Access Compliance Report

Public Rights-of-Way

Intersection ID: 12519	Main Street: E_6TH_ST	Cross Street: N_CALDWELL_ST	Location: E
ADA ID: 3CBDB453C7A3	Ramp Type: Perp	Initial Pass/Fail: Fail	Overall Compliance: No
		Severity Score: 8.75

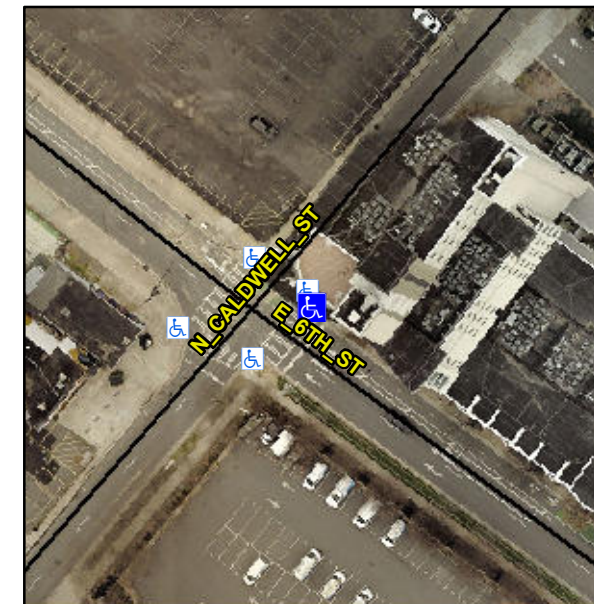
Not Found, R304.5.1

Compliance	Description	Data	Compliance	Description	Data
N/A	Ramp Length (in)	90.0	Yes	Ramp Slope (%)	7.8
No	Ramp Width (in)	47.5	Yes	Ramp XSlope (%)	0.5
N/A	Flare Type LT	N/A	N/A	Flare Type RT	N/A
N/A	Flare Slope LT (%)	N/A	N/A	Flare Slope RT (%)	N/A
N/A	Flare Traversable LT?	N/A	N/A	Flare Traversable RT?	N/A
N/A	Landing Length (in)	N/A	N/A	DWS Provided?	N/A
N/A	Landing Width (in)	N/A	N/A	DWS Contrast?	N/A
N/A	Landing Slope (%)	N/A	N/A	DWS Length (in)	N/A
N/A	Landing X Slope (%)	N/A	N/A	DWS Full Width?	N/A
N/A	Landing Curb? (Y/N)	N/A	N/A	DWS Offset (in)	N/A
N/A	Shared Landing?	N/A			
N/A	Gutter Ponding?	N/A	N/A	Gutter Slope (%)	N/A
N/A	Gutter Lip Ht (in)	N/A	N/A	Gutter X Slope (%)	N/A
N/A	Painted X Walk1?	Yes	N/A	Painted X Walk2?	N/A
	X Walk 1 Direction	To SW		X Walk 2 Direction	N/A
N/A	X Walk 1 Width (in)	108.5	N/A	X Walk 2 Width (in)	N/A
	X Walk 1 Slope (%)	8.7		X Walk 2 Slope (%)	N/A
	X Walk 1 X Slope (%)	2.2		X Walk 2 X Slope (%)	N/A

Remove & Replace Entire Ramp.
